# **Intel 82374/5 EB/SB EISA Bridge PCIsset Specification Update**

October 1997

Order Number 297735-003

The Intel 82374EB/SB and 82375EB/SB EISA Bridge may contain design defects or errors known as errata which may cause the product to deviate from published specifications. Current characterized errata are documented in this Specification Update.

**Figure 2: PLD Workaround #1**

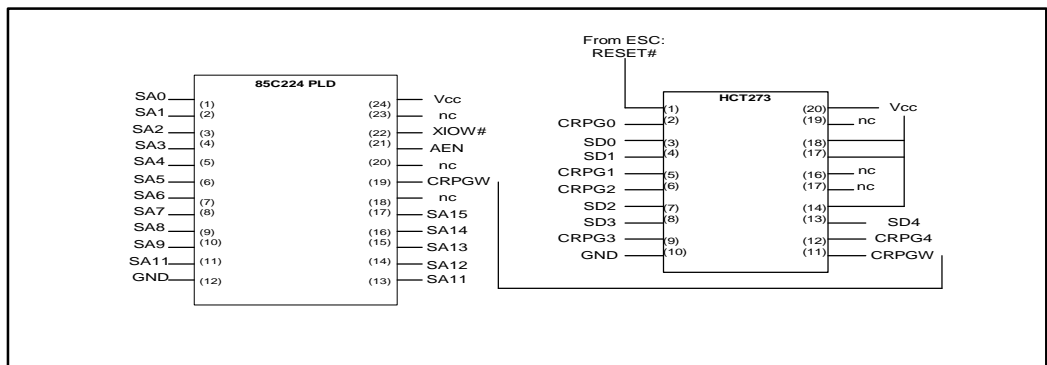
**PROBLEM:** EISA configuration RAM data. The 82374EB may not generate the proper page address on the LA[31:27]# lines during configuration RAM accesses under the following conditions: A DMA cycle or ISA refresh cycle, followed by another pending DMA, followed by an access to EISA configuration RAM (an EISA master should create the same problem).

**IMPLICATION:** During the configuration RAM reads, the 82374EB decodes the cycle properly and generates the signals necessary for the access. The system tries to access page xxxxx and program the proper page address into the C00h register. The 82374EB should drive xxxxx on LA[31:27]# at this time, but instead these address lines may float under the failing scenario. These address lines float when NMFLUSH# (New Master Flush) is asserted. NMFLUSH# gets asserted because of the back to back masters (EISA/ISA/refresh) being serviced.

1. The 85C224 PLD in fig. 2 is programmed to generate an IO write to I/O port 0C00h, which the ESC integrates as a configuration RAM page register. Upon seeing 0C00h on the address bus (SA[15:0]), AEN

asserted high for EISA bus master cycles, and an XIOW# asserted low, the PLD will drive its only output, CRPGW asserted high, as the clock signal input for the HCT273.

The reason for the driving the output high is that the HCT273 needs to see a rising edge on this clock signal in order to latch the correct CRAM page address. The HCT273 is an Octal D-type flip flop which is enabled on the rising edge of its clock signal input. The HCT273 will latch the correct CRAM page address off the data bus (SD[4:0]) and drive the address on its output signals (CRPG[4:0]). CRPG[4:0] are the synthesized versions of LA[31:27] and are tied to the corresponding inputs on the NVRAM. This solution is transparent to the system BIOS.

The actual pin assignments are given in fig. 2 above. This also includes the asserted values of the inputs and outputs (/ = symbol for asserted low). The following is the PLD equation (written in PLDshell Plus) for the data setup of the correct CRAM page address:

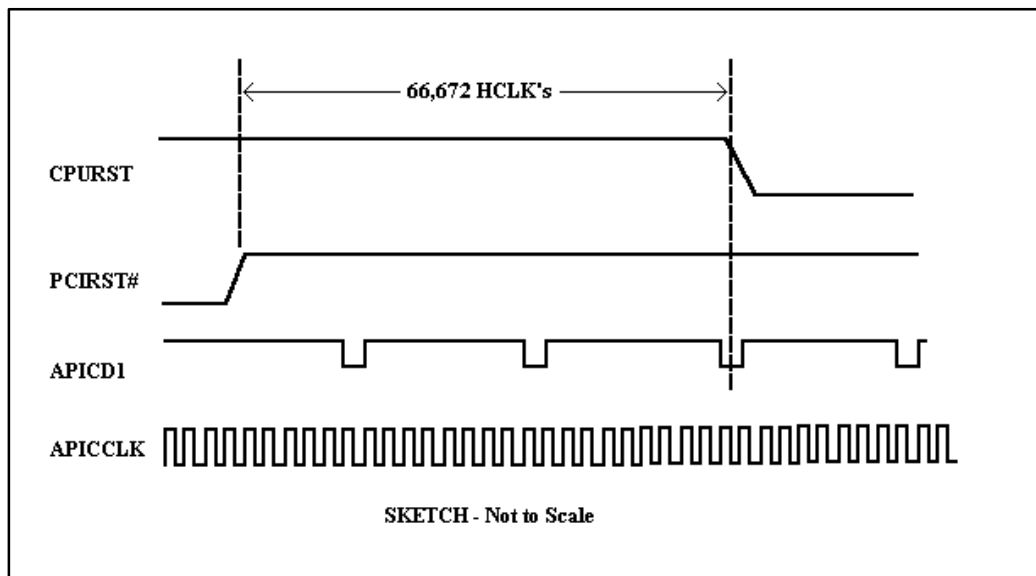
If a processor has its Local APIC setup in Through Local Mode (virtual wire), the 82374SB can potentially deassert and then reassert INTR before the interrupt acknowledge cycle for the first interrupt completes. When this happens, the CPU ignores the second interrupt and the system eventually hangs because no further interrupts will be serviced.

The CPU's local APIC does not recognize that an interrupt acknowledge has occurred until BRDY# is returned to the CPU for the second interrupt acknowledge bus cycle on the host bus. The 82374SB will deassert INTR soon after the FRAME# occurs on the PCI bus for the interrupt acknowledge cycle. If another interrupt occurs and INTR reasserts before BRDY# gets returned to the CPU by the 82434NX PCMC (or any Host to PCI bridge component), the interrupt will not be recognized.

Analysis of the 82434NX PCMC during an interrupt acknowledge cycle shows that a maximum of 106 HCLKs can occur between FRAME# and BRDY# being asserted on the host bus. The ESC can reassert INTR as soon as 74 host clocks after receiving FRAME# of the interrupt acknowledge cycle. There is a "window" of 32 HCLKs in which INTR can be reasserted by the ESC.

One workaround could use a combinatorial circuit using LOCK# and MI/O# from the processor to block the assertion of INTR until the interrupt acknowledge cycle has completed. Loading and timing on the LOCK# and MI/O must be considered for this workaround as they are host bus signals. The following would be the logic equation used for INTR:

Another workaround can be implemented by delaying any assertion of INTR by 32 host clocks. An RC circuit on the output of the required external 3.3V translation buffer (required for the B0 stepping of the ESC) signal can also accomplish this delay. The 32 host clocks is only valid for systems which use the 82434NX host bridge.

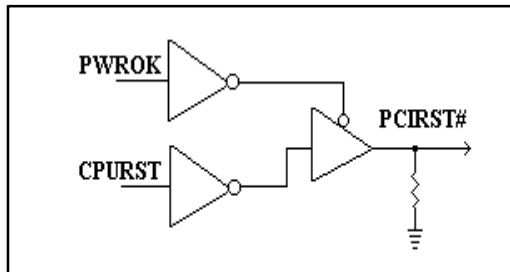
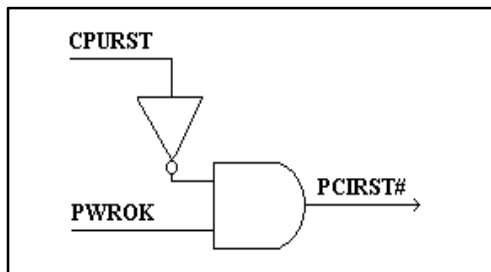
From the time that PCIRST# deasserts until the time that CPURST deasserts, the I/O APIC periodically pulses APICD1 low for one out of every 20 APICCLK's. If the pulse on APICD1 (APICEN) aligns with the falling edge of CPU RESET (CPURST), the local APIC's will not be enabled; this prevents proper DP or DP-ready functionality. See the figure below.

**Workaround #2:** Add logic to ensure that PCIRST# remains asserted low until PWROK is valid and then once PWROK is valid, let PCIRST# become the logical inverse of CPURST. This ensures that the I/O APIC and both CPU's exit reset simultaneously thereby preventing the I/O APIC from responding to the phantom APIC messages.

a) Connect a buffered version of CPURST to an inverter and then connect the output of this inverter to the input of a three-state buffer. PWROK# is used as the active low enable to the three-state buffer. The output of this three-state buffer is used as the PCIRST# signal for the entire system. Note that the PCMC PCIRST# output pin (pin 147) should be disconnected from the system.

It is important to use a buffered version of CPURST and preferably one that already exists in the system due to the critical AC timing of this signal. A weak pulldown resistor (8.2K, for instance) should be added to the PCIRST# net to ensure it is low while PWROK is low.

b) Connect a buffered version of CPURST to an inverter and then connect the output of this inverter to one input of a two-input AND gate. PWROK is the second input to the AND gate. The output of the AND gate becomes PCIRST# for the entire system. Again, the PCMC PCIRST# output pin (pin 147) should be disconnected from the system.

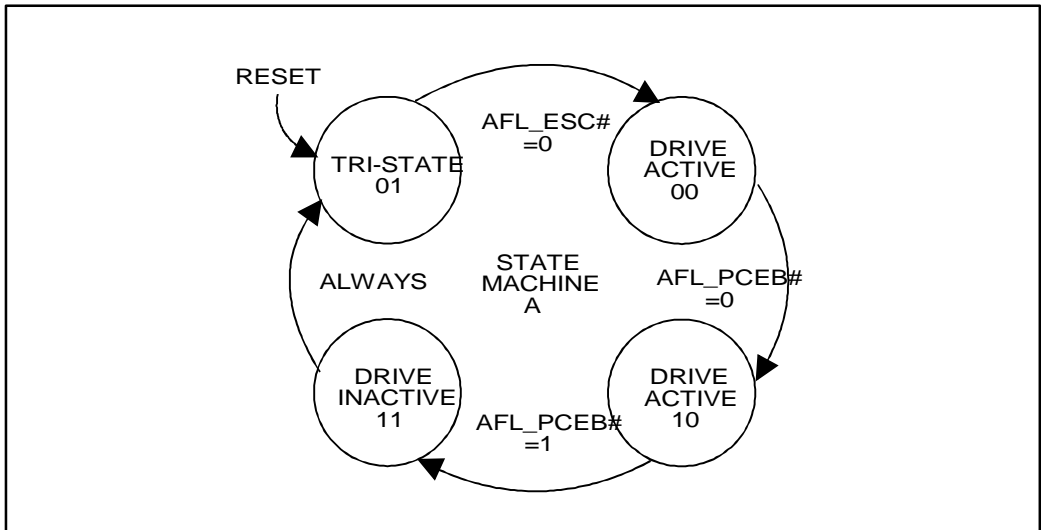
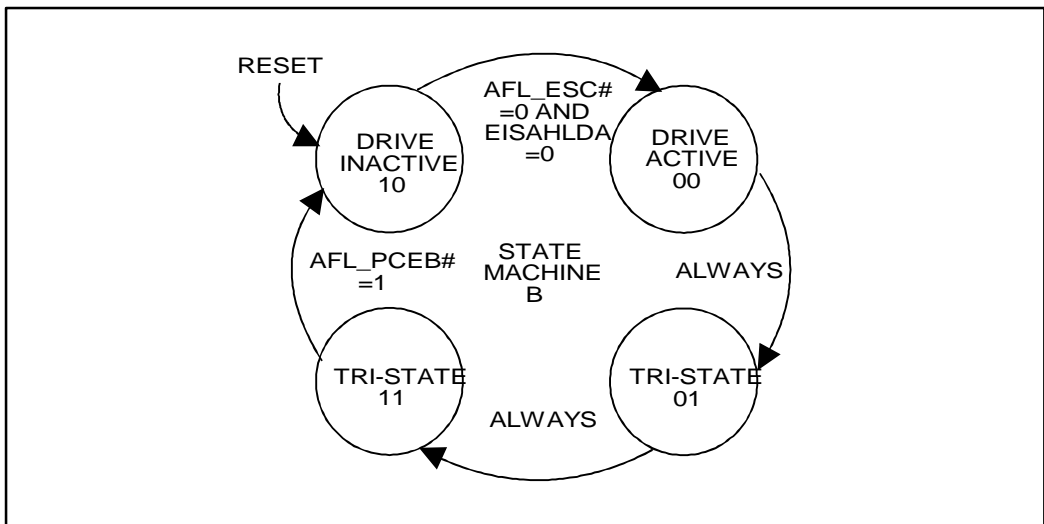
**PROBLEM:** In DP mode and during EISA/ISA/DMA transfers to PCI, an internal AC timing in the PCEB line buffers is violated, resulting in incorrect data driven onto the PCI bus. The failing scenario occurs during an APIC interrupt while the line buffers are flushing data and at the same time filling data. During that time, there is a window where the line buffer pointers do not change correctly.

The second workaround is designed to intercept the AFLUSH# signal between the PCEB and ESC (see figure below) in order to temporarily inhibit the assertion of the AFLUSH# signal to the PCEB. The AFLUSH# signal is held negated if there is an EISA-to-PCI transaction taking place. Once EISAHLDA is negated, the workaround will initiate the AFLUSH# protocol between the ESC and PCEB which will allow the APIC interrupt message to be sent to the processors. The workaround employs two state machines (using the PCI clock) that emulate the AFLUSH# logic from the both the PCEB and ESC perspectives.

- State Machine A (SMA) waits for the AFLUSH# signal from the ESC
- Once the ESC drives AFLUSH#, SMA will assert and hold AFLSH\_ESC#
- State Machine B (SMB) waits for the bus via EISAHLDA
- Once EISAHLDA is 0 (bus not busy) SMB asserts AFL\_PCEB# for 1 clock
- The PCEB assert AFLUSH# until buffers are flushed
- The PCEB signals the buffers are flushed by negating AFLUSH#

- g) SMA drives AFLSH\_ESC# inactive, then tri-states
- h) SMB comes out of tri-state and negates AFLSH\_PCEB# which is the default position for the ESC
